**ATCO Gas Australia Proposed
Access Arrangement for the Mid-West and
South-West Gas Distribution Systems**

**Review of Technical Aspects of
the Proposed Access Arrangement**

**Report to
Economic Regulation Authority of
Western Australia**

**from
Energy Market Consulting associates**

Figure 36: AA5 Brownfields growth NPV analysis – ATCO base case as presented

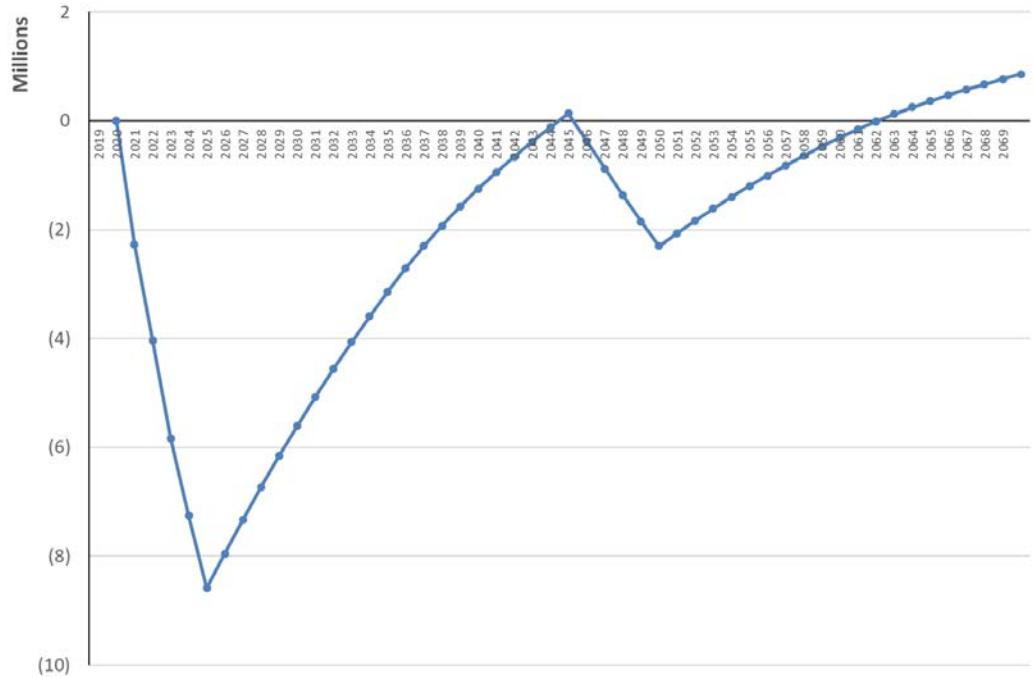
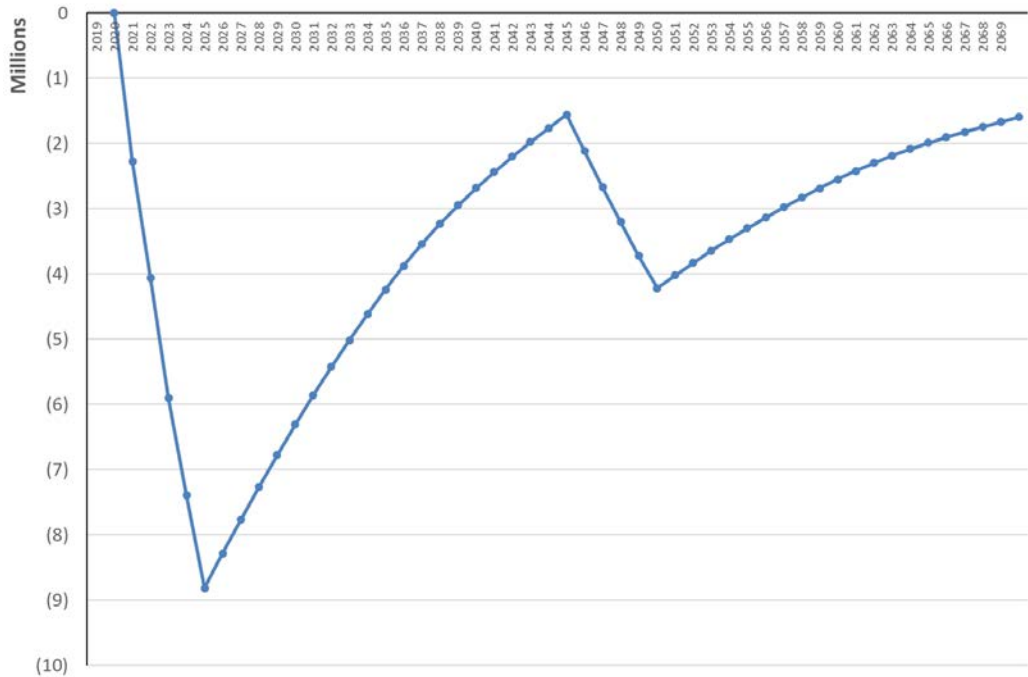
- 610. With ATCO's prevailing (i.e. 2019) tariffs assumed, ATCO's incremental revenue test would remain negative over the entire period, with an NPV of negative \$1.1m at 25 years, and negative \$1.0m still at 50 years.
